Proposal Request

PROJECT: *(name and address)*
AWSOM
Bentonville, Arkansas

PROPOSAL REQUEST 101

RFI #512 Public Gallery 1101 Receptacles

POWER - LEVEL 1 PLAN - AREA A
1/8" = 1'-0"

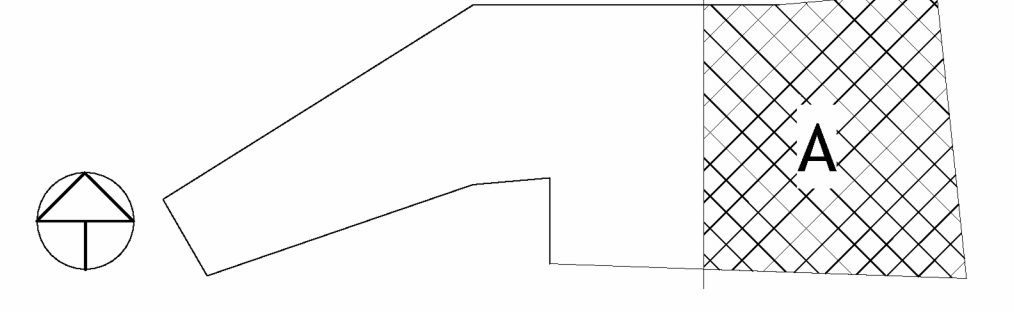
- 1) **ELECTRICAL**
 - a) Refer to Revised Sheet **E201A**, with original issue date 02.24.2023 and revised date 12.02.24.
 - Clarify mounting location for receptacles associated with displays to be installed within accessible ramp cavity for future display screens.

INSTALL RECEPTACLES FOR FUTURE DISPLAY SCREENS LOW WITHIN ACCESSIBLE RAMP CAVITY AS COORDINATED IN RFI 512.

INSTALL RECEPTACLES FOR FUTURE DISPLAY SCREENS LOW WITHIN ACCESSIBLE RAMP CAVITY AS COORDINATED IN RFI 512.

1 PUBLIC GALLERY 1101 SIGNAL FLOW DIAGRAM

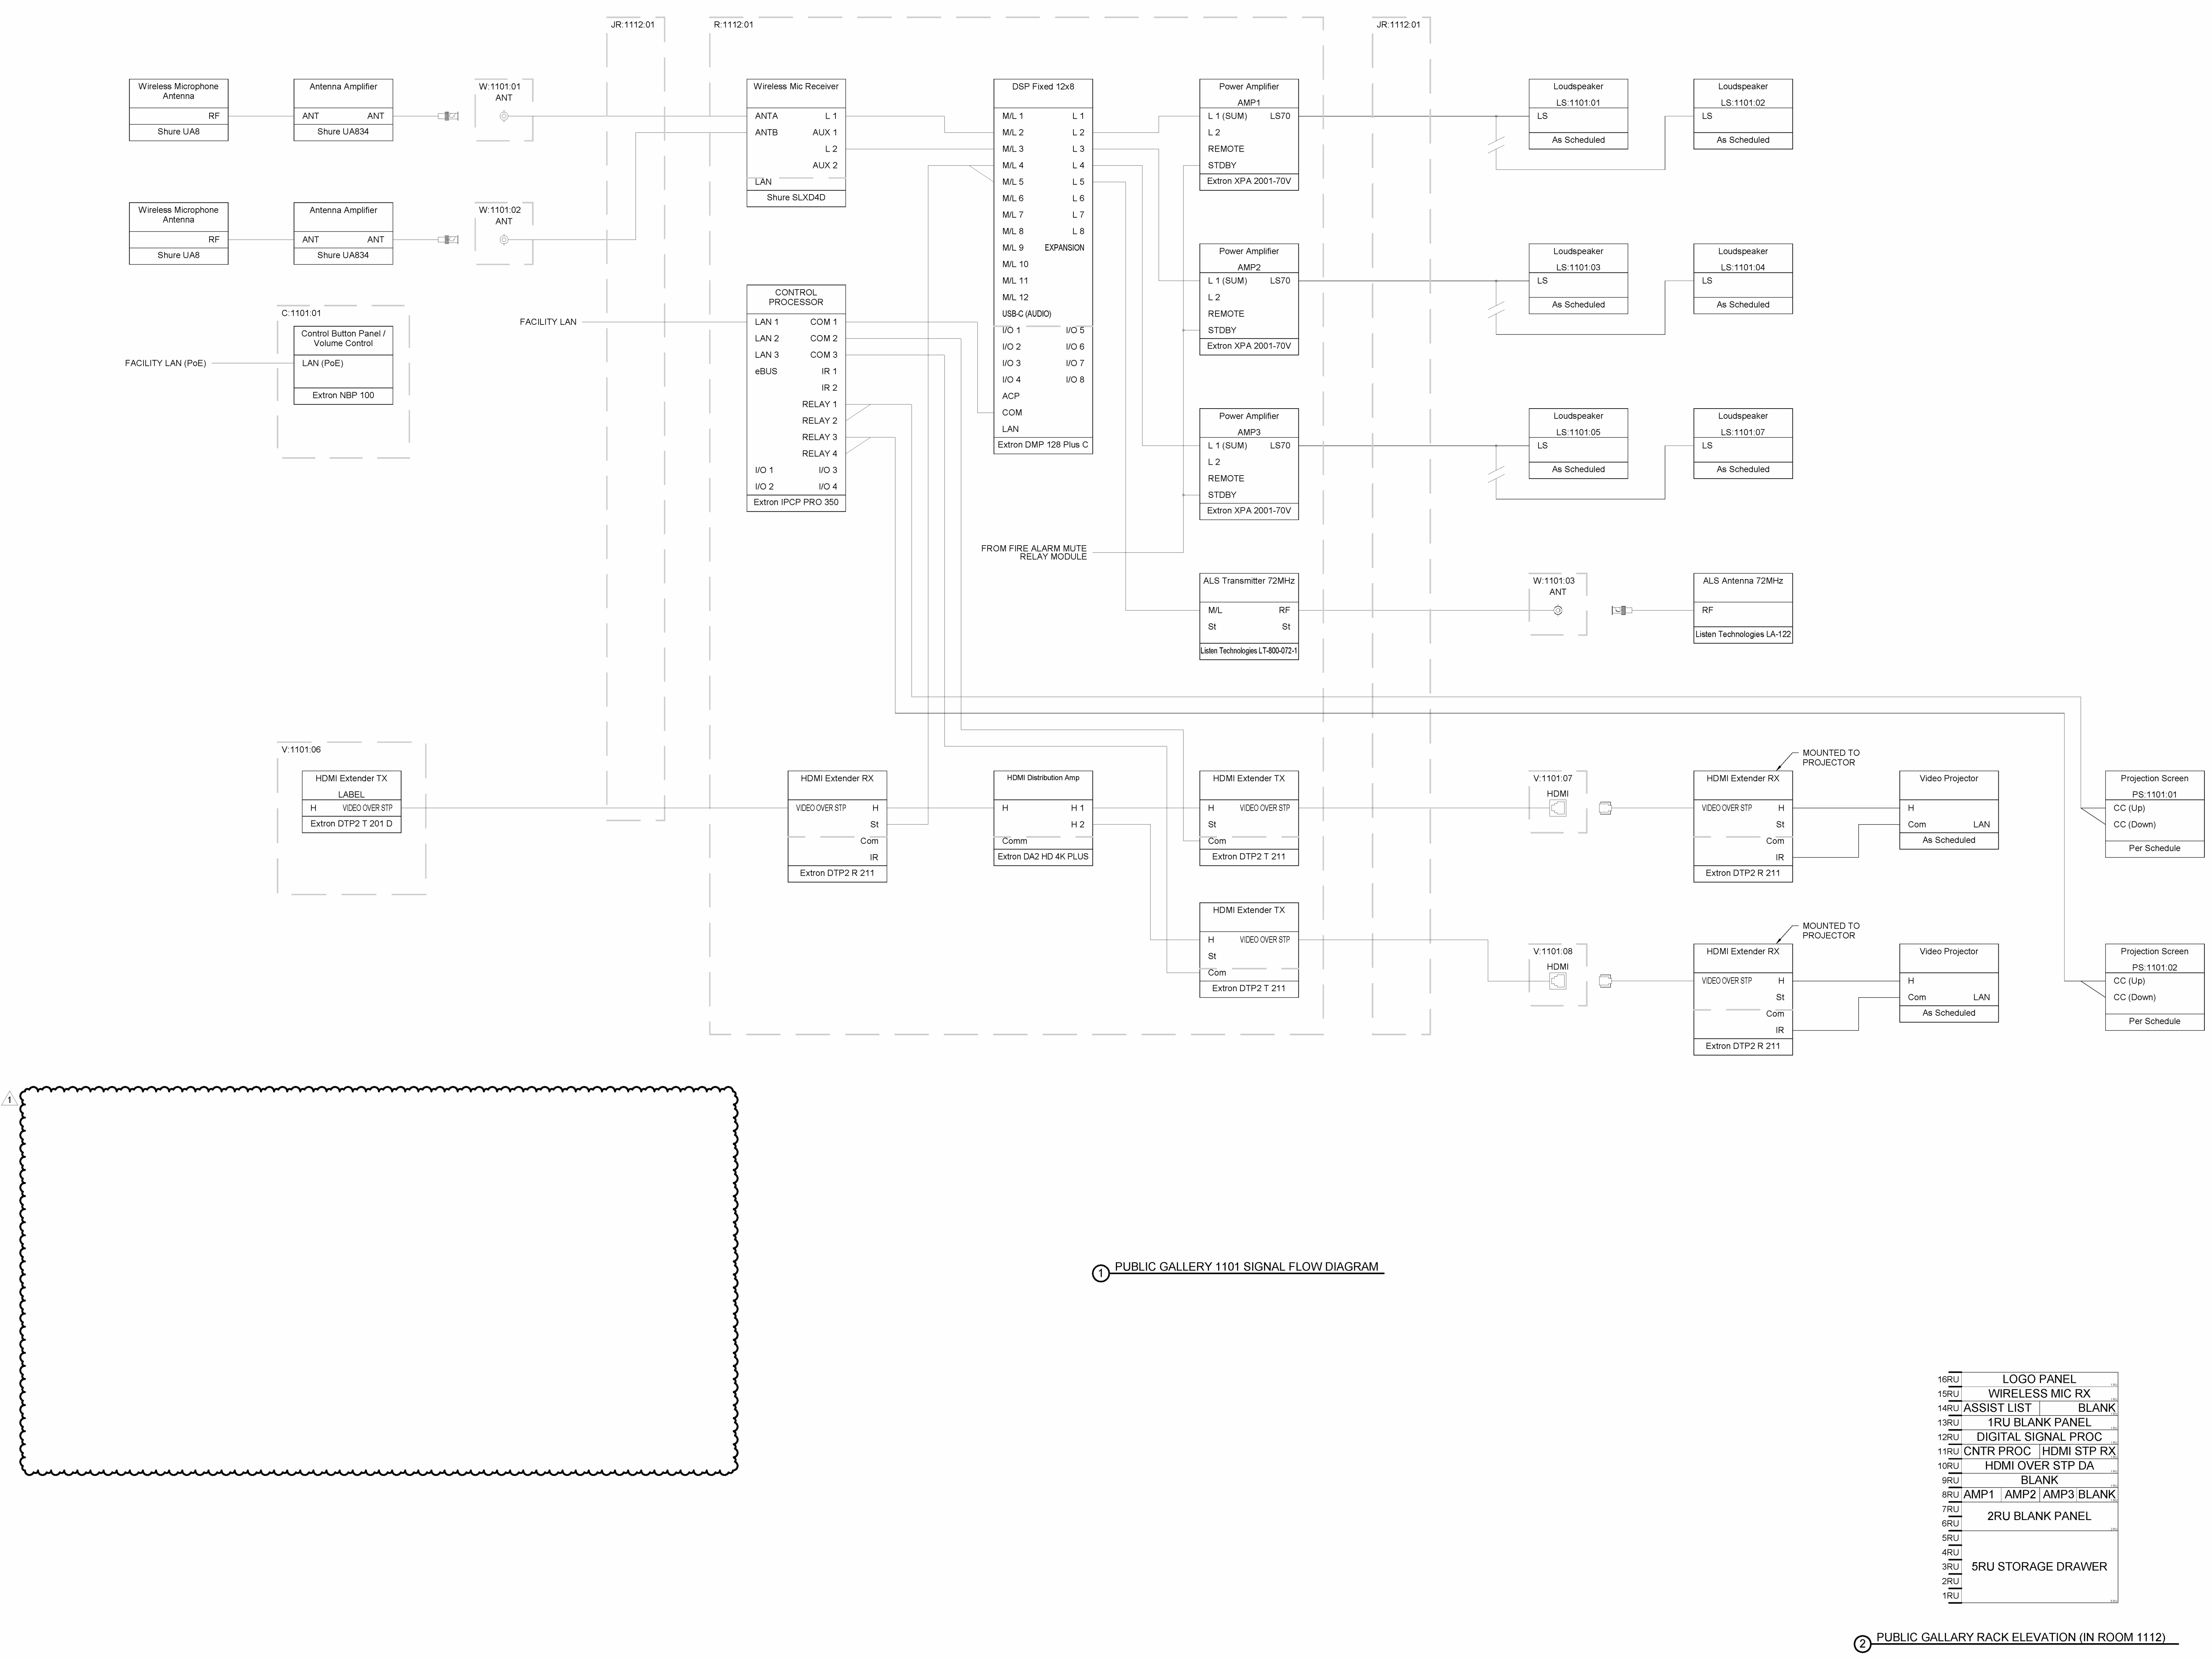
- Deleted flat panel displays from schedule to reflect changes on sheet TA101A.
 - d) Refer to Revised Sheet **TA705**, with original issue date 02.24.2023 and revised 12.02.24.

- Deleted flat panel displays to reflect changes on sheet TA101A.
 - (1) Adjust locations of TV outlets.
- 3) **TECHNOLOGY**
 - a) Refer to Revised Sheet **TN101A**, with original issue date 02.24.2023 and revised date 12.02.24.
